Access Compliance Report

Public Rights-of-Way (Curb Ramps)

Intersection ID: 15996	Main Street: CHESTNUT_LAKE_DR	Cross Street: HICKORY_HOLLOW_LN	Location: NW
ADA ID: E36459C7BC42	Ramp Type: Directional1	Initial Pass/Fail: Fail	Overall Compliance: No
		Severity Score: 25

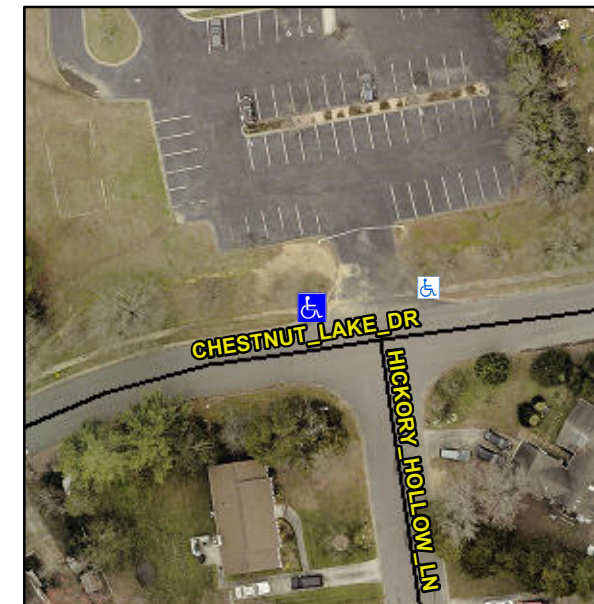
R304.5.3

Compliance	Description	Data	Compliance	Description	Data
N/A	Ramp Length (in)	68.0	N/A	Grade Break?	N/A
Yes	Ramp Width (in)	48.0	N/A	Grade Break Slope (%)	0.0
Yes	Ramp Slope (%)	6.2	N/A	Grade Break XSlope (%)	0.0
No	Ramp XSlope (%)	10.8			
N/A	Flare Type LT	N/A	N/A	Flare Type RT	N/A
N/A	Flare Slope LT (%)	N/A	N/A	Flare Slope RT (%)	0.0
N/A	Flare Traversable LT?	N/A	N/A	Flare Traversable RT?	N/A
N/A	Landing Length (in)	0.0	N/A	DWS Provided?	N/A
N/A	Landing Width (in)	0.0	N/A	DWS Contrast?	N/A
N/A	Landing Slope (%)	0.0	N/A	DWS Length (in)	N/A
N/A	Landing X Slope (%)	0.0	N/A	DWS Full Width?	N/A
N/A	Landing Curb? (Y/N)	N/A	N/A	DWS Offset LT (in)	N/A
N/A	Shared Landing?	N/A	N/A	DWS Offset RT (in)	N/A
N/A	Gutter Ponding?	0.0	N/A	Gutter Slope (%)	N/A
N/A	Gutter Lip Ht (in)	0.0	N/A	Gutter X Slope (%)	N/A
N/A	Painted X Walk1?	No		Road Slope (%)	1.2
	X Walk 1 Direction	To E		Road X Slope (%)	1.1
	X Walk 1 Width (in)	N/A		Clear Space?	N/A

Remove & Replace Entire Ramp.
